Town of Kittery Town Planning Board Meeting February 11, 2016

Yankee Commons Mobile Home Park Expansion – Final Subdivision Plan Review

**RE: Town of Kittery, Planning Board Services
Yankee Commons Mobile Home Park Expansion Review #4
(Tax Map 66, Lots 24 & 25)
CMA #591.65**

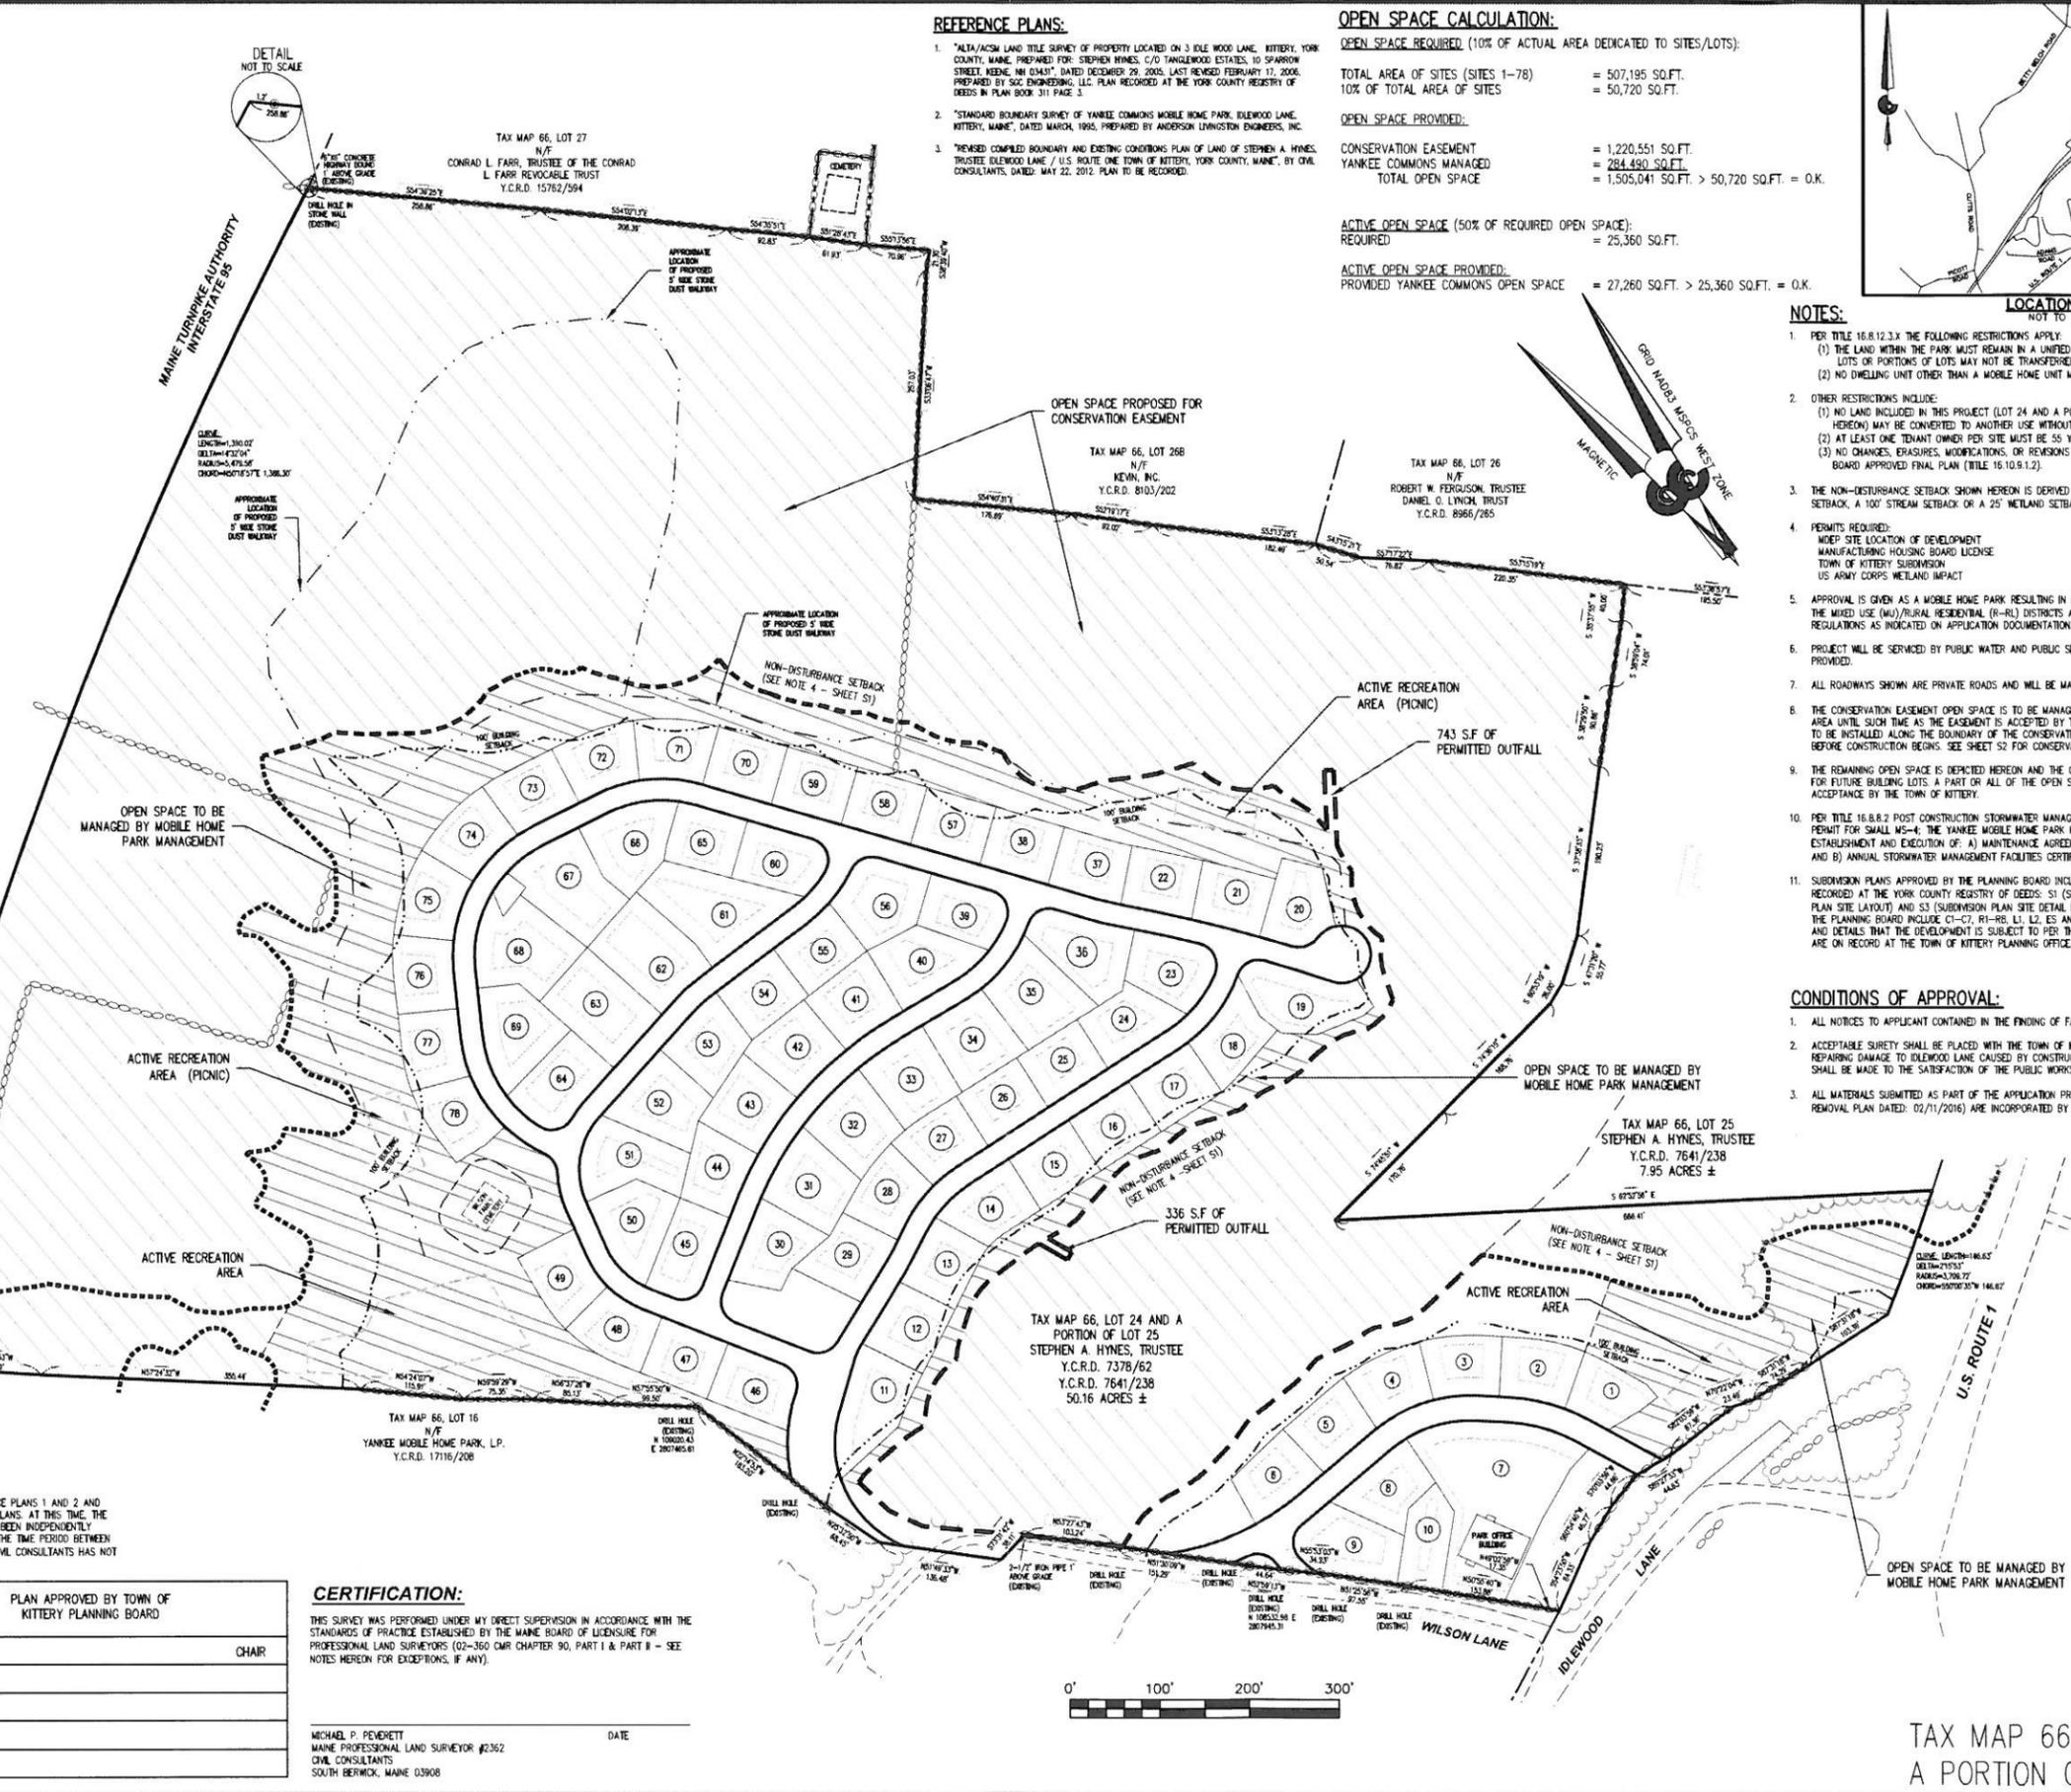
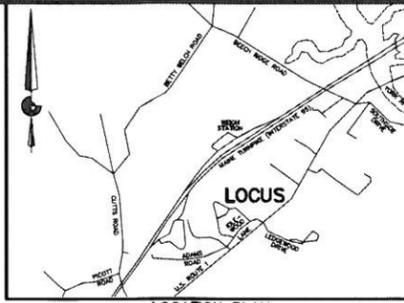
1) It appears that the required open space (10% of the total area of the lots) is not included in the proposed conservation easement (though there is a slight difference in totals between Sheet S1 and the exhibit OSP that is attached to the RTC). This may be important with regard to how the Board might consider the proposed conservation easement to the town.

6) The Subdivision Plan (sht-S-1) should include a plan note that addresses the "proposed conservation" easement. As mentioned under condition #7, if the "conservation easement is not executed what are the implications? Does the plan come back to the Planning Board? At this point it is not clear. Perhaps the "proposed" easement is better stated as "future" easement and/or a note that explains the intent and that it is not part of the regulatory requirements. The note might also state that it will be maintained as "open space" or as a "no-disturb area" by the mobile home park management until such time a conservation easement is executed. So the final plan's approval is in effect is not tied to the execution of the conservation easement or not. The applicant's agent has informed staff that the MDEP's stormwater permitting is not tied to the conservation easement and the land it encompasses as being maintained in a specific manner.

9) On the Subdivision Plan (S-1) notes refereeing to "no disturb" setback cites Sheet S-1, note 4, however, it is evident it is refereeing to another note on another sheet. The plan needs to be revised, perhaps "S-1" was meant to be "C-2". Same reference is also found on Sheet C-2, however, plan note #4 seems more applicable. It reads: "The non-disturbance setback shown hereon is either 75' emergent wetland setback, the 100' stream setback or the 25' wetland setback." It is not clear which one applies on the plan. Staff recommends that there is a single "no disturb" setback line depicted on the plan(s). This line may have to cover other regulatory lines, however, it would be clear as to where the "no-disturb" land is, especially important during construction.

- THE CONSERVATION EASEMENT OPEN SPACE IS TO BE MANAGED AS A NO CUT/NO DISTURBANCE AREA UNTIL SUCH TIME AS THE EASEMENT IS ACCEPTED BY THE TOWN OF KITTERY. MARKERS ARE TO BE INSTALLED ALONG THE BOUNDARY OF THE CONSERVATION EASEMENT AS SHOWN HEREON BEFORE CONSTRUCTION BEGINS. SEE SHEET S2 FOR CONSERVATION EASEMENT LAYOUT.

CIVIL CONSULTANTS
 DRAWN GDC/JAA CALC.
 DATE 19 NOVEMBER 2015
 CHECKED
 APPROVED
 SCALE 1"=50'
 SHEET TITLE:
 •GRADING &
 DRAINAGE PLAN
 SHEET NUMBER:
C3
 SHEET C3 of C8
 PROJECT # 06-684.02

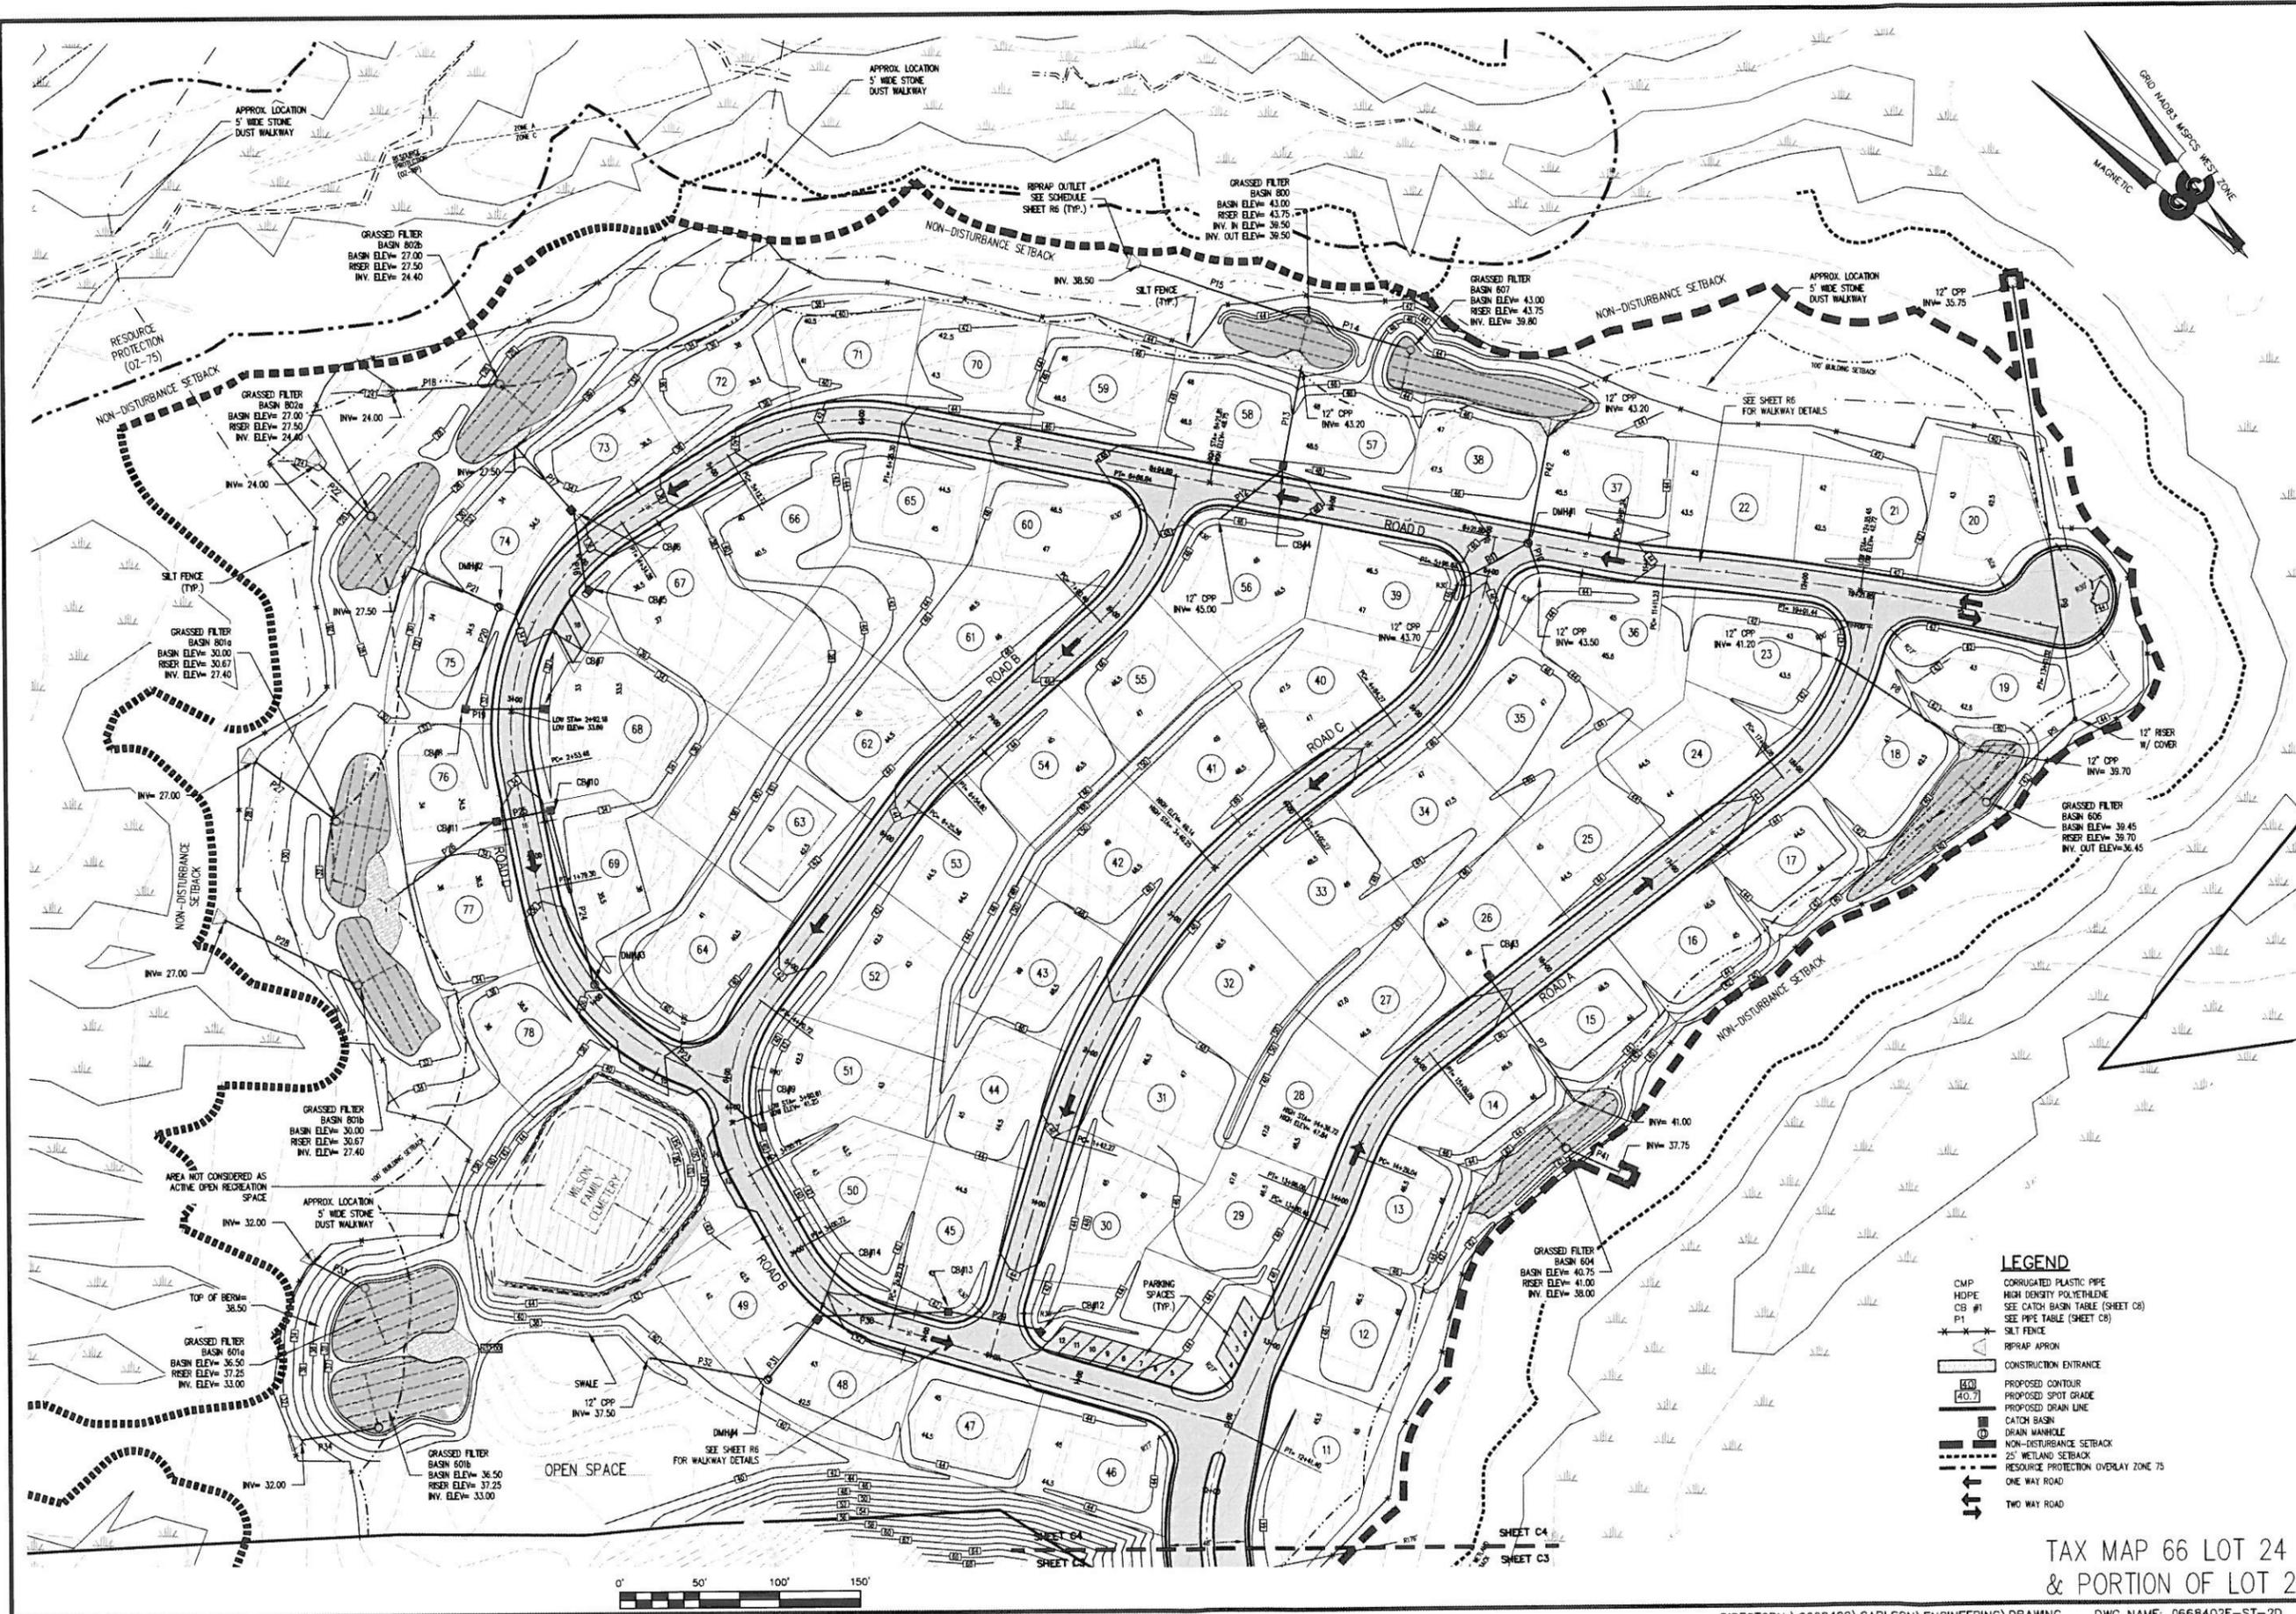
UPDATE: Typical street sections included on Sheet R6 have been revised to all include accommodation of a 3-foot wide area for a pedestrian walkway. Grading and Drainage Plans Sheets C-3 and C-4 also include plan notes referencing the typical sections on Sheet R-6. It appears that there will be a pedestrian way throughout the primary development site connecting to the community center and Idlewood Lane.

175 **RESPONSE:** All of the Typical Road Cross-Sections shown on Plan Sheet R6 now include provisions
176 for Walkways.
